Access Compliance Report

Public Rights-of-Way

(Curb Ramps)

Main Street: VAN_BUREN_ST Cross Street: FLIGHT_AVE Location: NE

ADA ID: RPRK210930125221 Ramp Type: Type 1 - Perpendicular Diagonal Initial Pass/Fail: Fail Overall Compliance: No Severity Score: 2

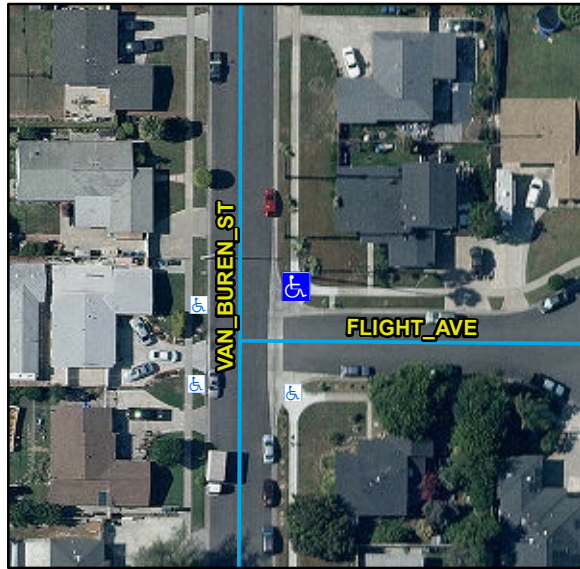
Compliance	Description	Data	Compliance	Description	Data
N/A	Ramp Length (in)	129	N/A	Flare Type LT	
Yes	Ramp Width (in)	48			N/A
Yes	Ramp Run Slope (%)	8.3	N/A	Flare Slope LT (%)	N/A
No	Ramp Cross Slope (%)	4	N/A	Flare Traversable LT	N/A
N/A	Landing Present	N/A	N/A	Flare Type RT	
N/A	Landing Length (in)	N/A			N/A
N/A	Landing Width (in)	N/A	N/A	Flare Slope RT (%)	N/A
N/A	Landing Run Slope (%)	N/A	N/A	Flare Traversable RT	N/A
N/A	Landing Cross Slope (%)	N/A	N/A	DWS Provided	N/A
N/A	Landing Movement Obstructed?	N/A	N/A	DWS Contrast	N/A
	Landing Movement Type	N/A	N/A	DWS Length (in)	N/A
N/A	Landing Shared	N/A	N/A	DWS Full Width	N/A
N/A	Clear Space	Yes	N/A	DWS Offset Left (in)	N/A
N/A	Clear Space To Crosswalk (in)	N/A	N/A	DWS Offset Right (in)	N/A
N/A	Marked Crosswalk 1	No	N/A	Marked Crosswalk 2	No
	Crossing 1 Direction	W		Crossing 2 Direction	S
	Marked Crosswalk 1 Width (in)	N/A		Marked Crosswalk 2 Width (in)	N/A

N/A	Ramp Inside Crosswalk 1	N/A	Yes	Ramp Inside Crosswalk 2	N/A
	Crossing 1 Slope (%)	2.2		Crossing 2 Slope (%)	0.8
	Crossing 1 Cross Slope (%)	1.8		Crossing 2 Cross Slope (%)	1.8
N/A	Gutter Ponding	N/A	N/A	Curb Slope	3.6
Yes	Gutter Lip Height (in)	0		Road Run Slope (%)	2.2
N/A	Gutter Run Slope (%)	N/A		Road Cross Slope (%)	1.9
N/A	Gutter Cross Slope (%)	N/A			
Yes	Overall Surface Condition: Acceptable		Yes	Perp Joint Present	Yes
	Cross Gutter Present?	Yes		Spandrel Present?	Yes
	Replace Cross Gutter?	No		Replace Spandrel?	No

Remove & Replace Curb Ramp With Two New Directional Ramps or Equivalent.

R304.5.3, STD 1115
